CALL NO. 102
CONTRACT ID NO. 211311
ADDENDUM # 1

Subject: Boone County, CM 8124 (023)
Letting March 19, 2021

- (1) Revised - Proposal Bid Items - Pages 101-103 of 103
- (2) Revised - Plan Sheets - R5 General Summary, S006 Foundation Layout, S009 End Bent, T001 Lighting Quantities, T001 Signal Quantities, T006 Lighting Plan, T006 Signal Plan

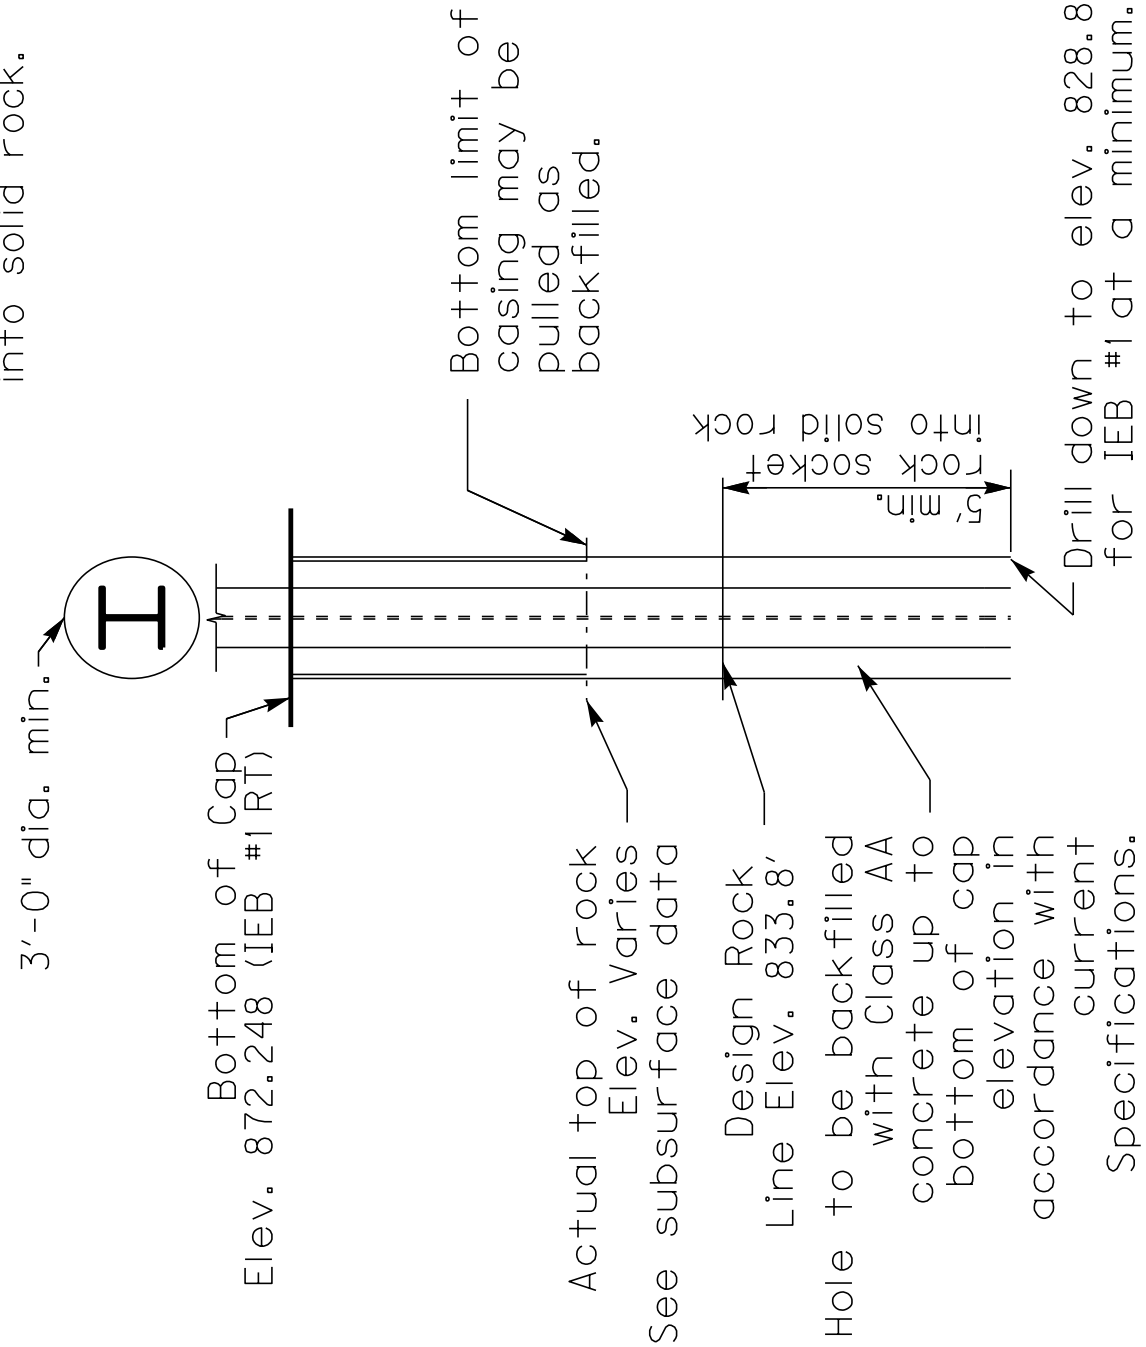
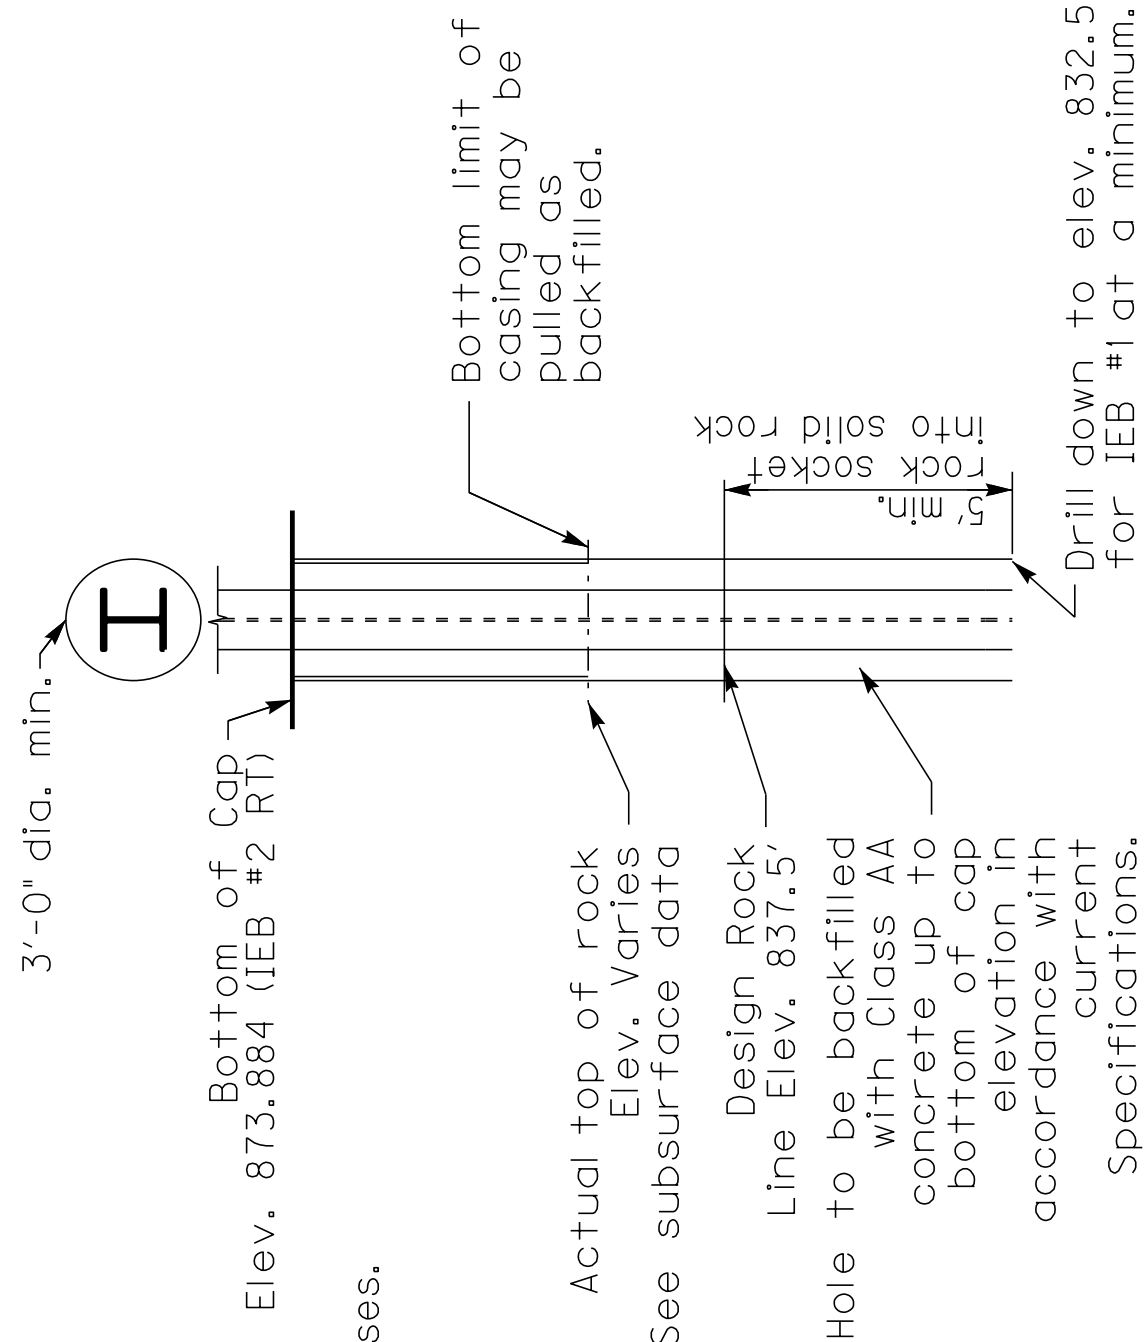
Note: The solid unweathered rock elevation was assumed to be at Elev. 837.5' at EB #2 for design purposes. Estimated pile tip is 832.5' but may be adjusted based on rock elevation. Maintain 5'-0" min. embedment into solid rock.

Note: The solid unweathered rock elevation was assumed to be at Elev. 833.8' at EB #1 for design purposes. Estimated pile tip is 828.8' but may be adjusted based on rock elevation. Maintain 5'-0" min. embedment into solid rock.

Note: The solid unweathered rock elevation was assumed to be at Elev. 837.5' at EB #2 for design purposes. Estimated pile tip is 832.5' but may be adjusted based on rock elevation. Maintain 5'-0" min. embedment into solid rock.

SIGNAL PLAN
US 42 @ I-75 RAMP

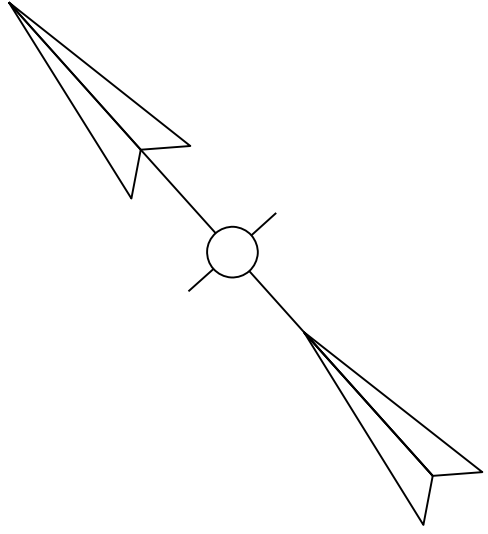
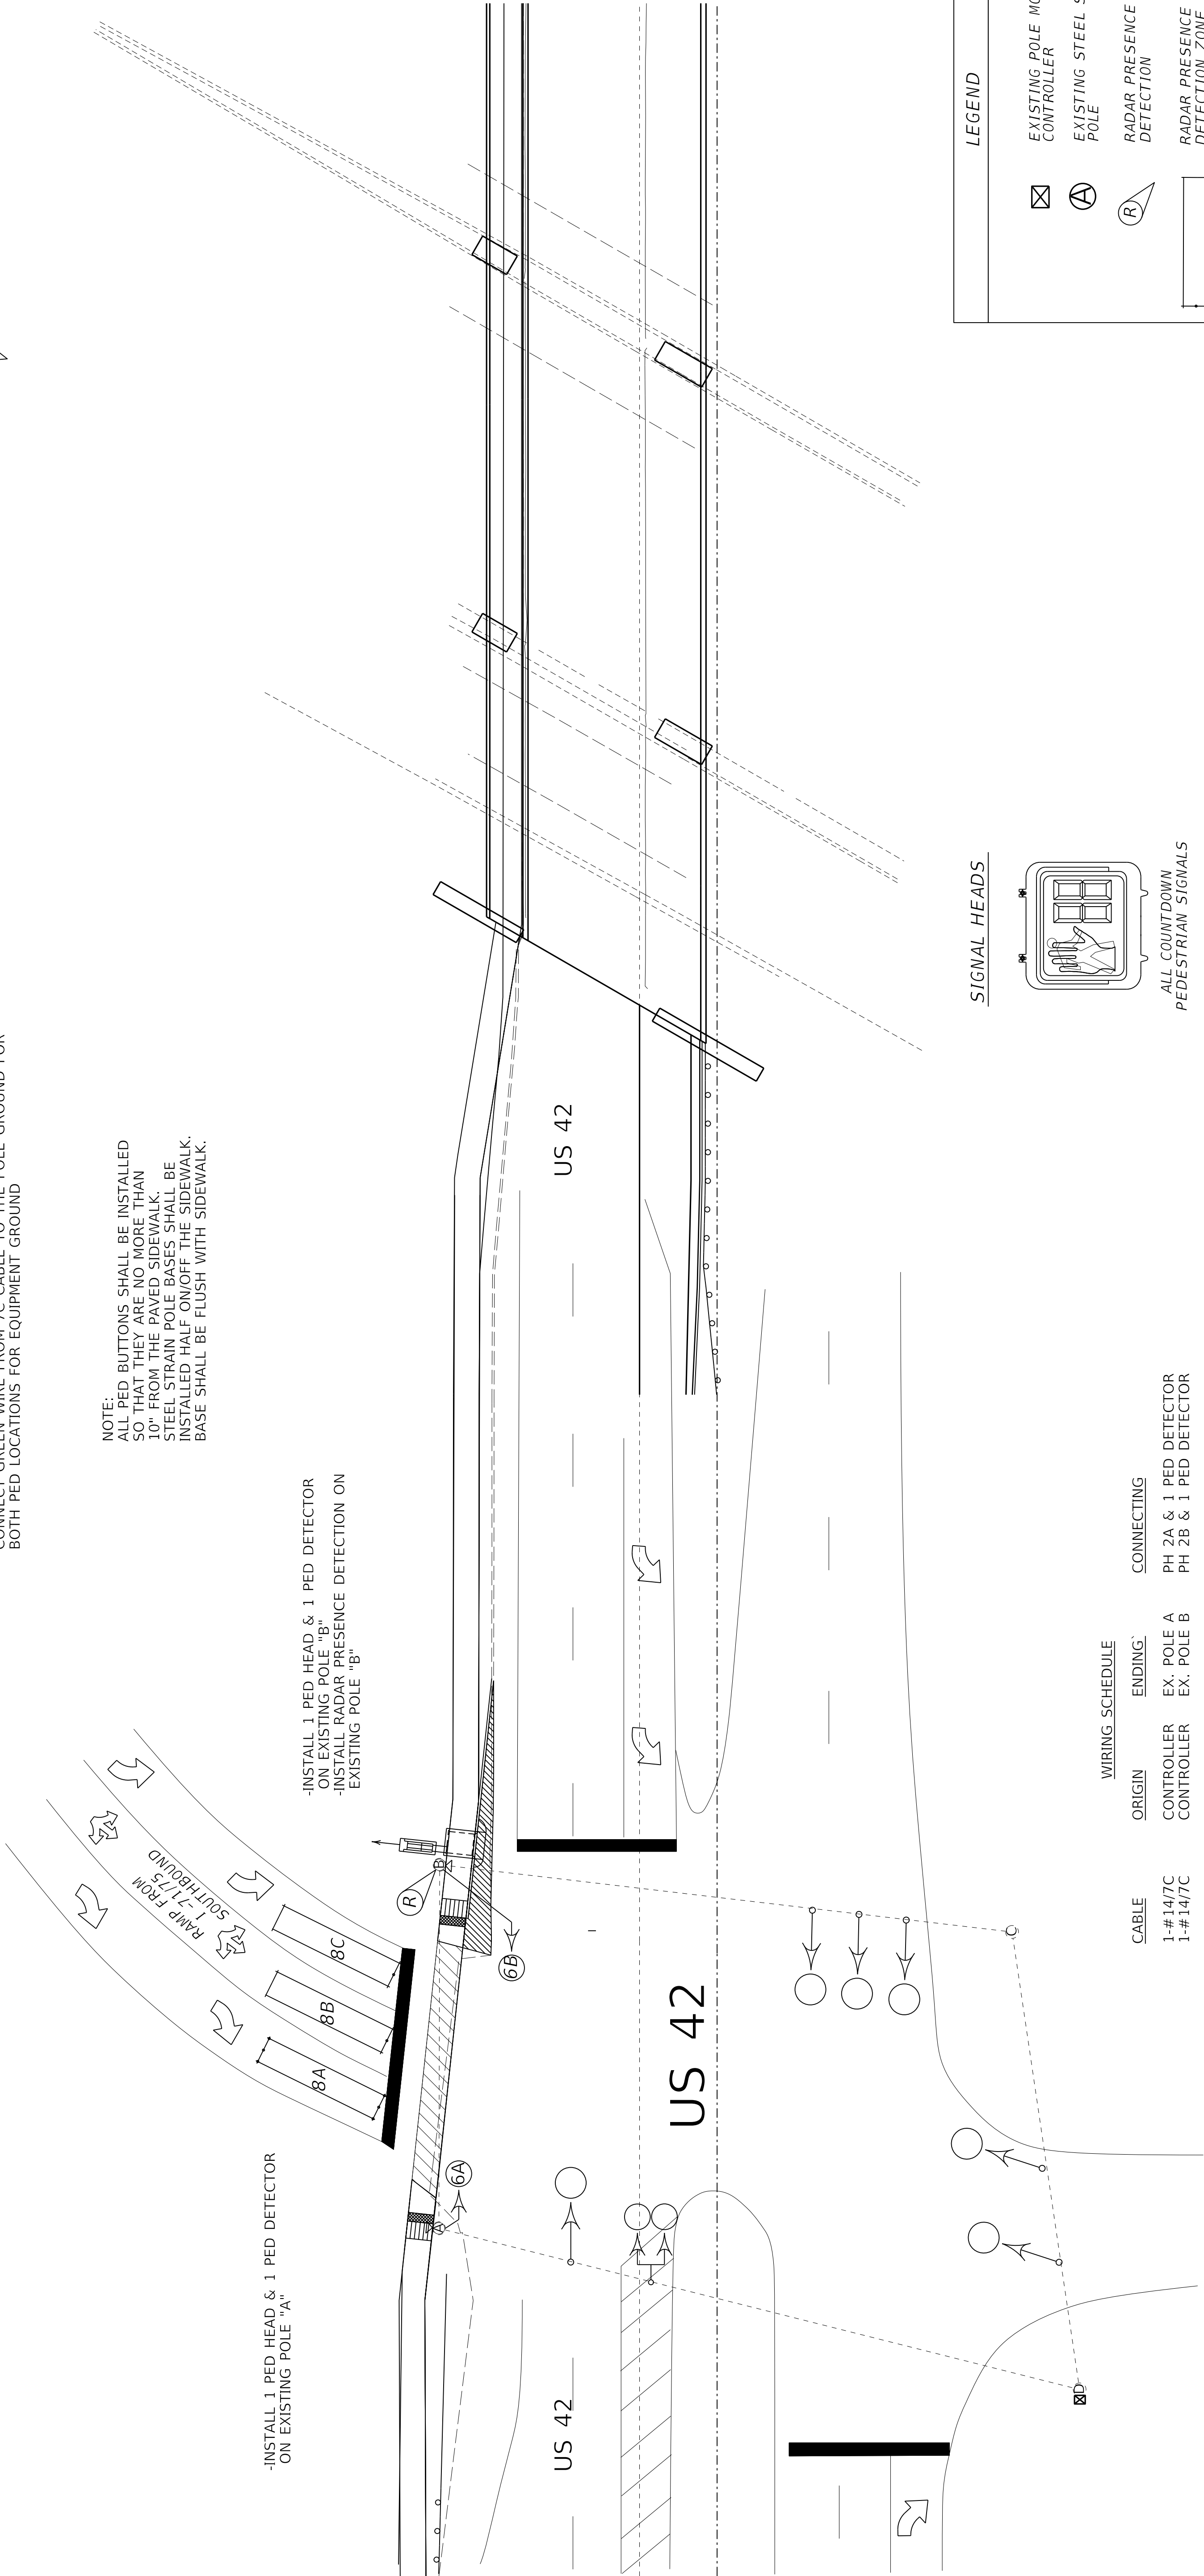
CHANGE FROM 5C TO 7C

CHANGE FROM 5C TO 7C
